## **PLANTATION MEMORIAL GARDENS SUBDIVISION**

APPLICATION NUMBER 11 DATE September 1, 2011

REQUEST Sub division

# DETAIL SITE PLAN

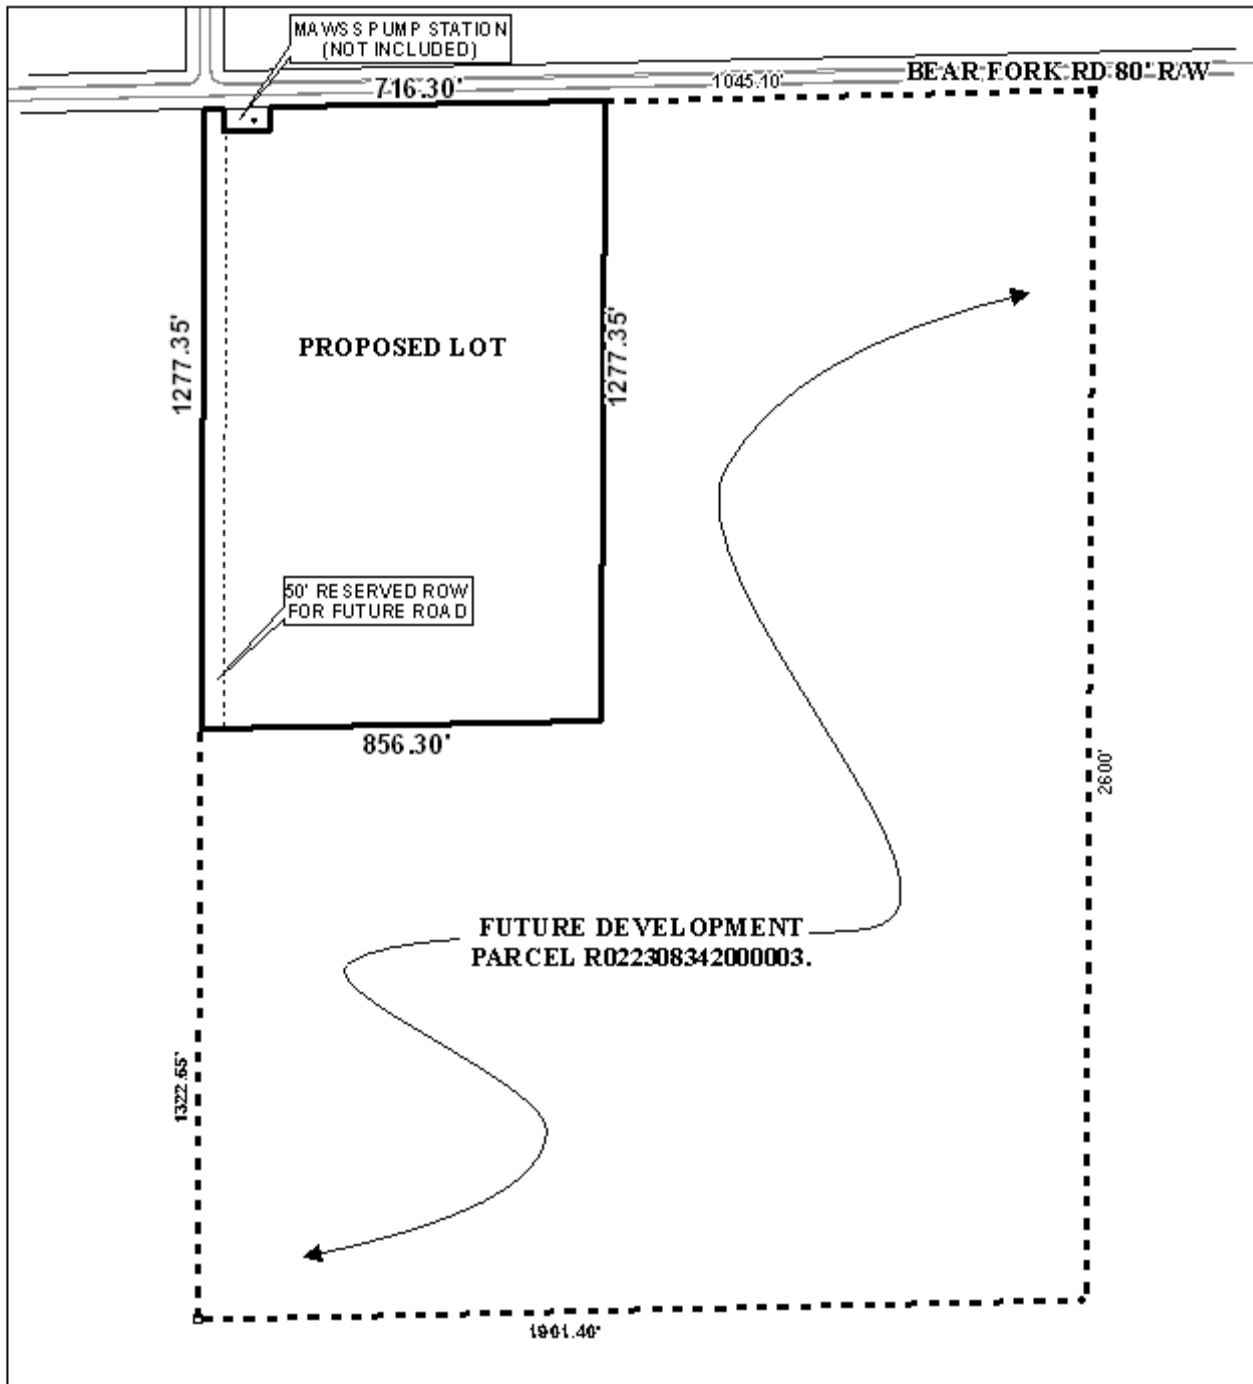
While Bear Fork Road is a minor street, access management is a concern. The site plan depicts one curb-cut onto Bear Fork Road, although the proposed lot has nearly 900 feet of frontage onto Bear Fork Road. To ensure consistency with the submitted site plan, the proposed lot should be limited to one curb-cut to Bear Fork Road, with the size, design and location to be approved by Traffic Engineering and Planning, and to comply with AASHTO standards.

The 25-foot minimum building setback line along Bear Fork Road is depicted on the detailed preliminary plat, and a 75-foot setback is depicted along the Western boundary, to accommodate the proposed right-of-way for Middle Ring Road and the setback. These setbacks are not depicted on the overall preliminary plat that shows the entirety of the parcel – the proposed lot and the future development area. The “50’ reservation for future road” label should be removed, and instead be relabeled as a “50’ setback in-lieu of dedication for future road” for the plat. The overall plat should also depict these setbacks.

- 4) Revision of the site plan to depict the 25-foot minimum building setback from both the Bear Fork Road and proposed Middle Ring Road frontages;
- 5) Revision of the label for Middle Ring Road to depict the future right-of-way as a “50’ setback in-lieu of dedication for future road;”
